High School in Jerrabomberra

Response to Submissions and SDRP

30.03.2022

ACCESSIBILITY AND EQUITY | CONNECTION TO DAVID MADEW OVAL

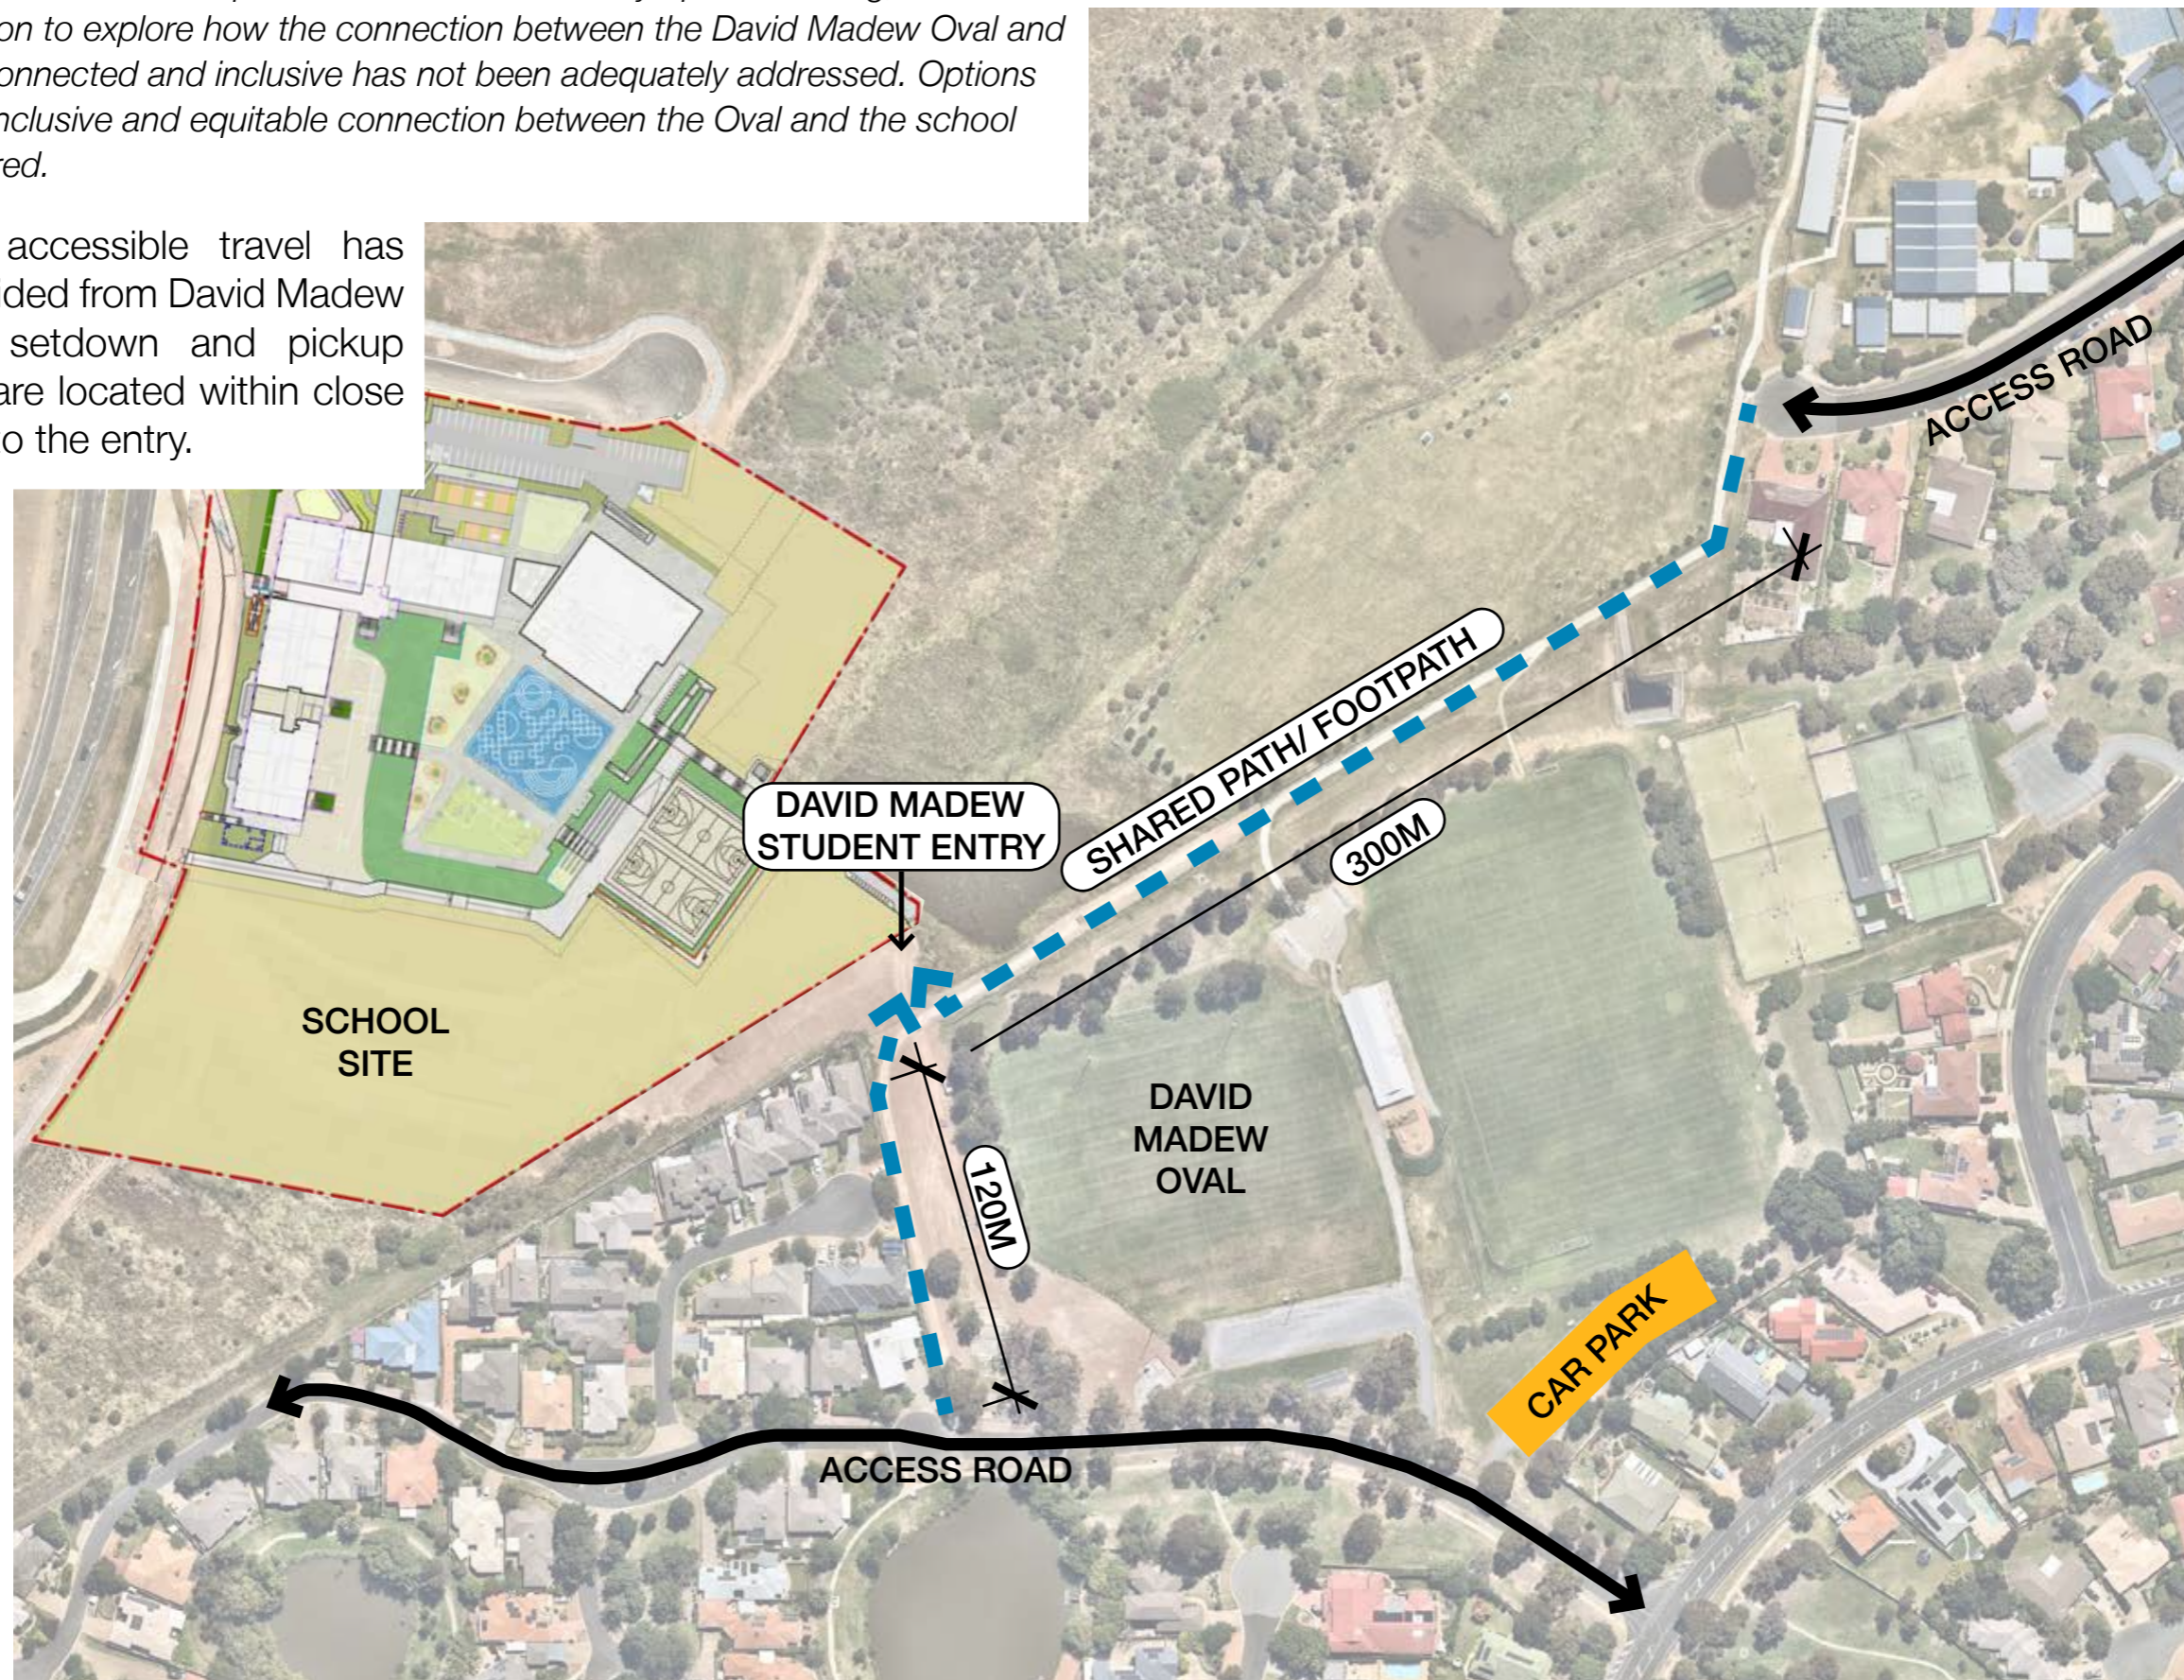
Recommendation 7c – the response does not include any options testing, and the recommendation to explore how the connection between the David Madew Oval and the school is connected and inclusive has not been adequately addressed. Options to provide an inclusive and equitable connection between the Oval and the school must be explored.

- Although accessible travel has been provided from David Madew oval, no setdown and pickup locations are located within close proximity to the entry.

- OPTION 1:

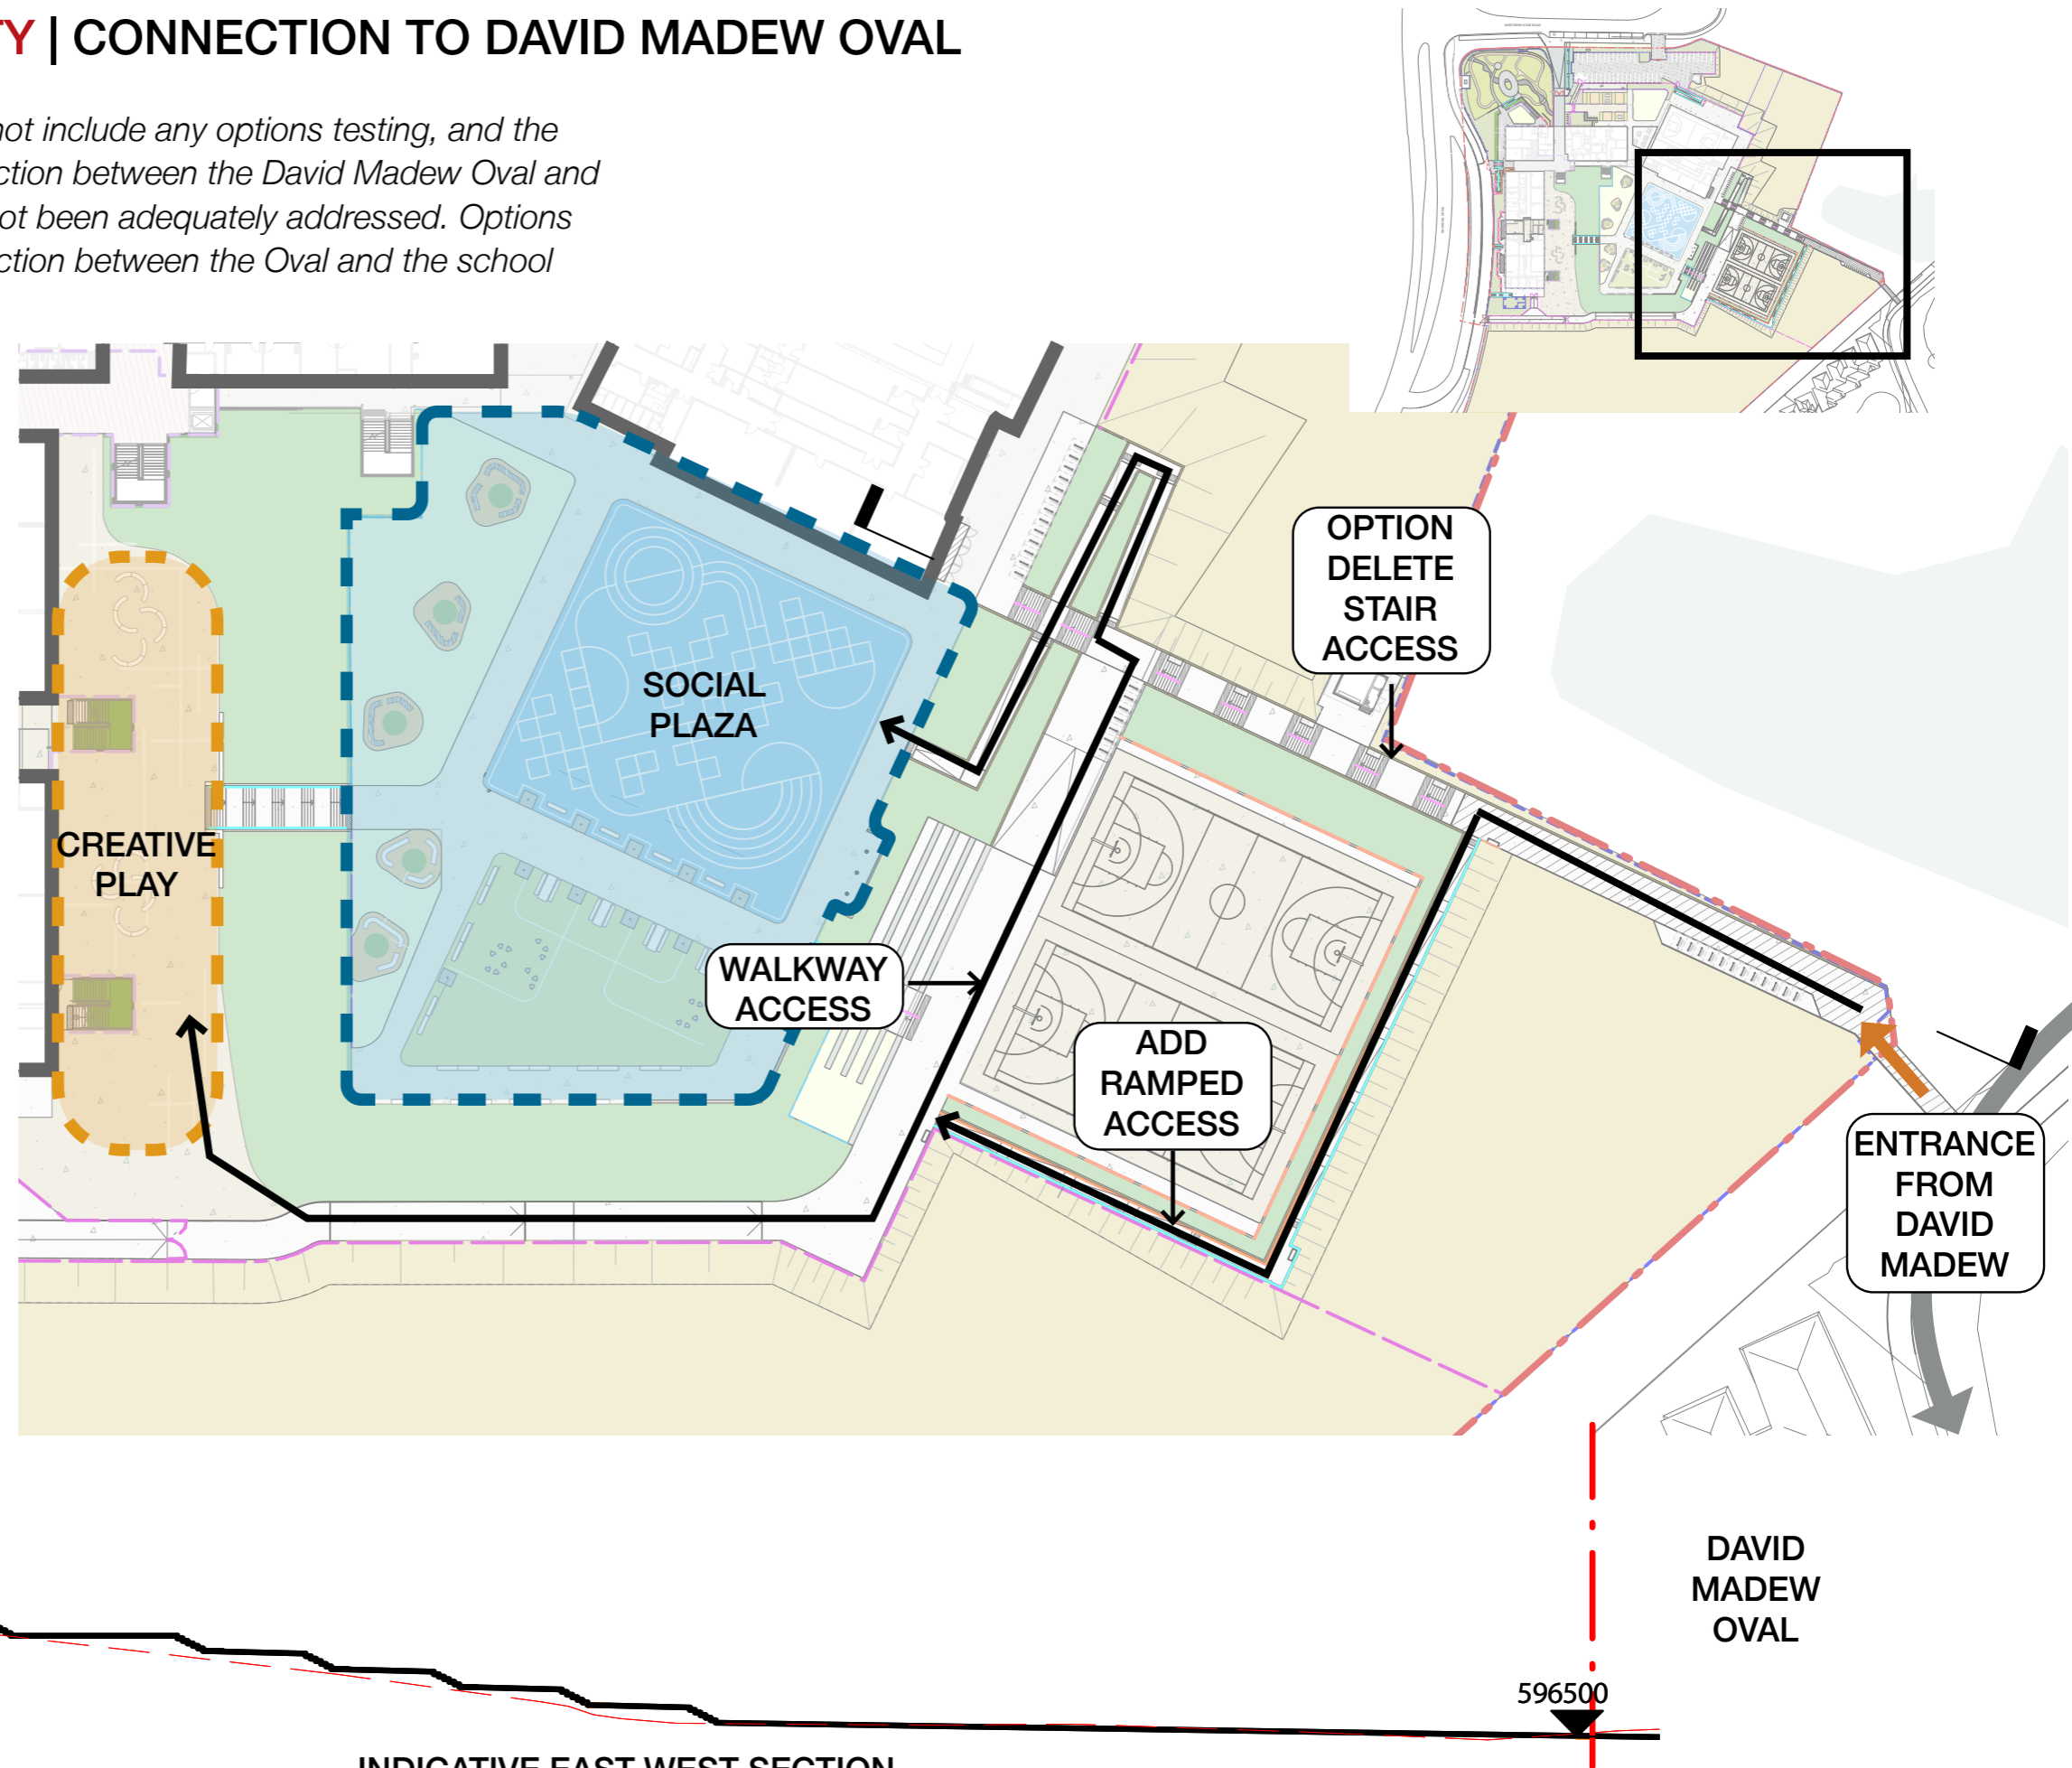
Recommendation 7c – the response does not include any options testing, and the recommendation to explore how the connection between the David Madew Oval and the school is connected and inclusive has not been adequately addressed. Options to provide an inclusive and equitable connection between the Oval and the school must be explored.

- Stair access to the Social Plaza is provided via a rise of 7 flights of stairs to navigate the 7.8 meters level difference of the natural contours
- Stair access can be deleted and replaced with a reamp system around the sports courts providing accessible and equitable travel for all users alike
- This option limits choice of travel paths for abled-bodies users
